HISTORIC AND DESIGN REVIEW COMMISSION

HDRC CASE NO: 2018-108
ADDRESS: 418 E HUISACHE AVE
LEGAL DESCRIPTION: NCB 3088 BLK 4 LOT 22 E 15 FT OF 21
ZONING: MF-33 H
CITY COUNCIL DIST.: 1
DISTRICT: Monte Vista Historic District
APPLICANT: Shannon O'Malley
TYPE OF WORK: Construction of a rear carport
APPLICATION RECEIVED: March 02, 2018
60-DAY REVIEW: May 01, 2018
REQUEST:

The applicant is requesting a Certificate of Appropriateness to construct a 1-story rear carport to measure approximately 400 square feet.

SITE PLAN

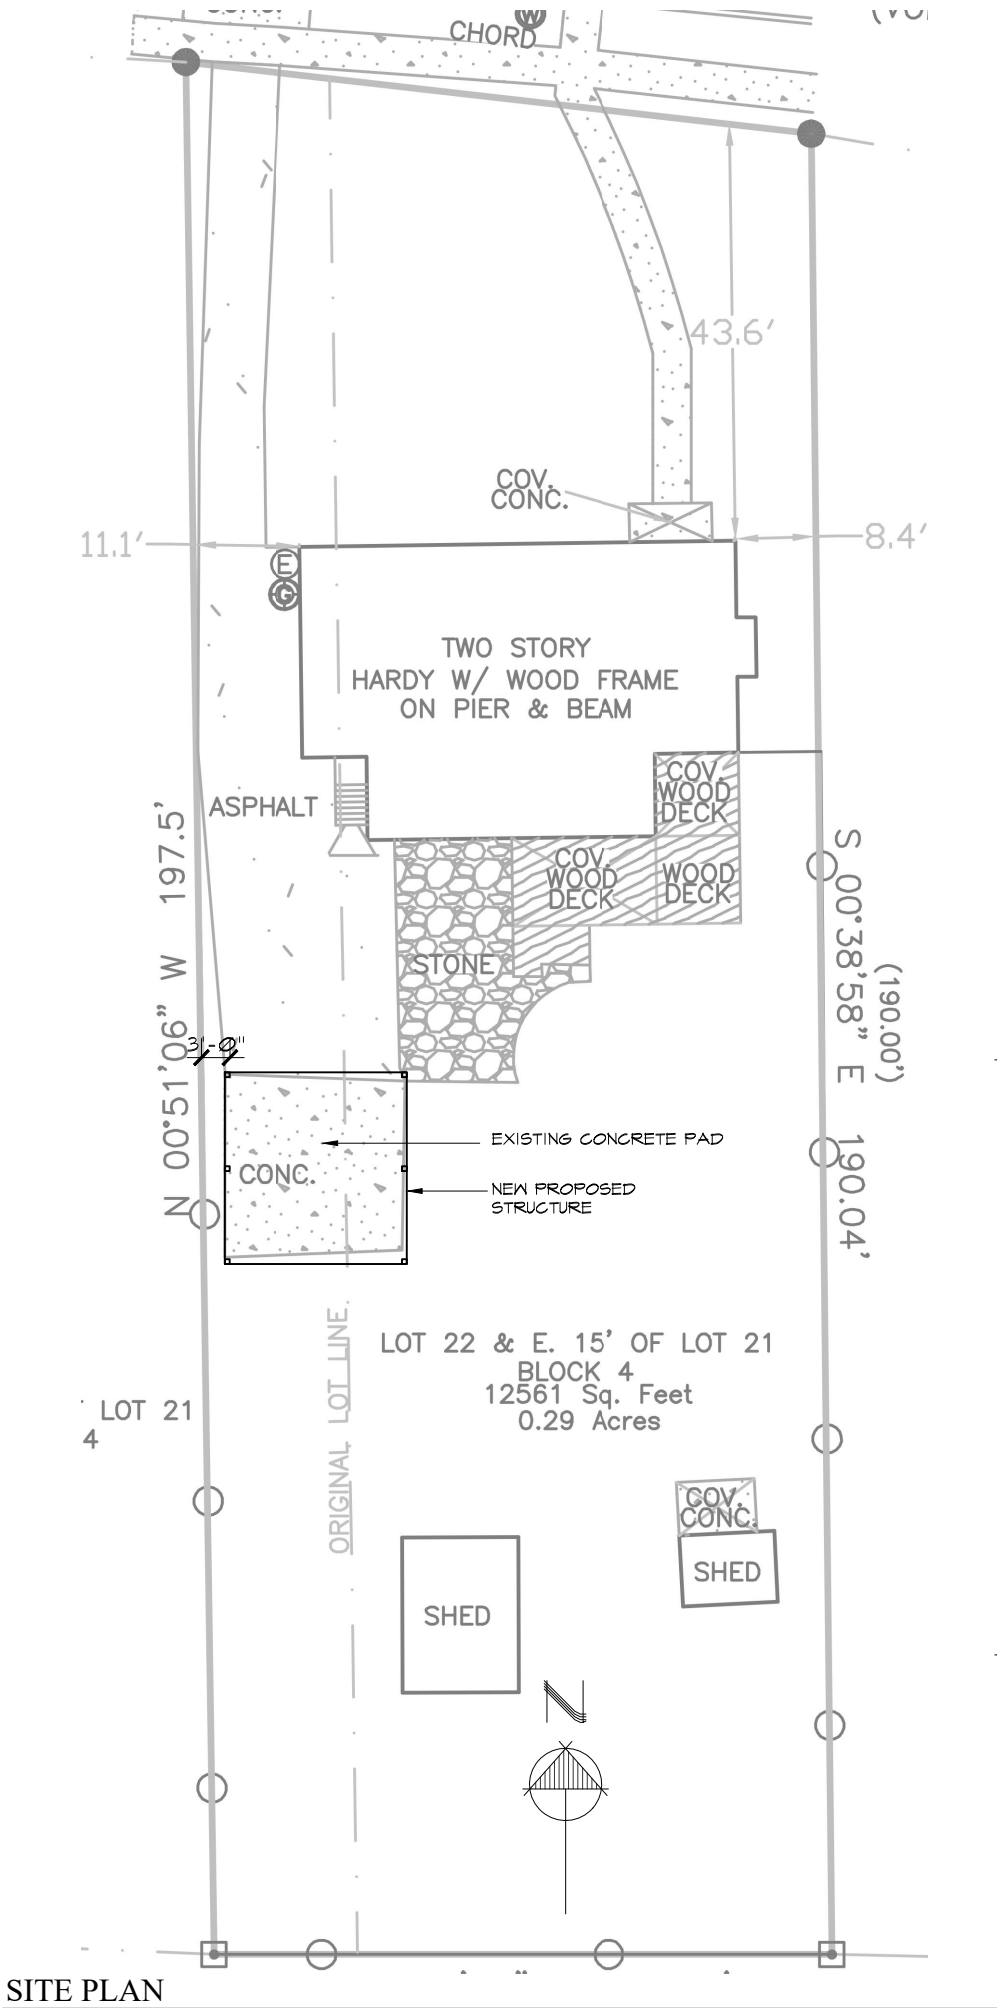
- c. **ORIENTATION AND SETBACK** – The applicant has proposed to orient the new accessory structure towards the street. Guidelines 5.B.i and 5.B.ii for new construction stipulate that new garages and outbuildings should follow the historic orientation and setbacks common in the district. Staff finds the proposal for orientation consistent with the Guidelines. The rear setback is also consistent with historic precedents in the Monte Vista Historic District, but staff has not seen a site plan that indicates the relationship of the placement of the structure to existing property lines. The applicant is responsible for complying with all zoning setback standards and filing for a variance with the Board of Adjustment if applicable.

- i. That the applicant installs smooth hardi siding with a reveal dimension that matches the primary structure.
- ii. That the applicant modifies the roof to feature a traditional sloped soffit instead of gable returns as noted in finding e.
- iii. That the applicant meets all setback standards as required by city zoning requirements, and obtains a variance from the Board of Adjustment if applicable.

FRONT ELEVATION

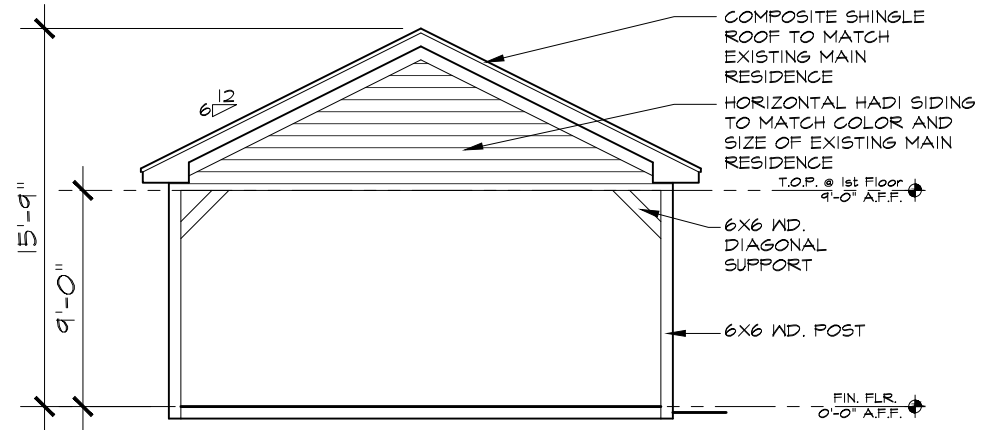
- e. **ROOF** – The applicant has proposed a gable roof form for the carport. The roof will be constructed of composite shingles to closely match the materiality of the primary structure, as well as composite board siding to match the siding of the primary structure. The roof also contains gable returns, which is not characteristic of historic roof forms or details. Staff finds the material consistent with the Guidelines, but finds that the roof should feature a traditional sloped soffit instead of gable returns.

SIDE ELEVATION

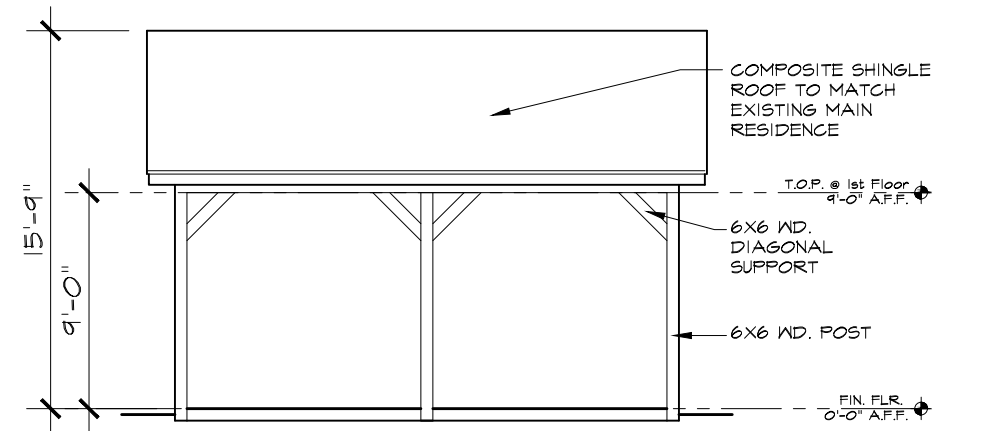
- d. **SCALE & MASS** – The applicant has proposed a 1-story carport structure with a gable roof. The structure will measure approximately 15'-9" in height. The Historic Design Guidelines state that new construction should be consistent with the height and overall scale of nearby historic buildings and rear accessory structure. The scale of the proposed structure does not impact or visually compete with 2-story primary structure on the lot or nearby historic structures. Staff finds the proposal consistent with the Guidelines.
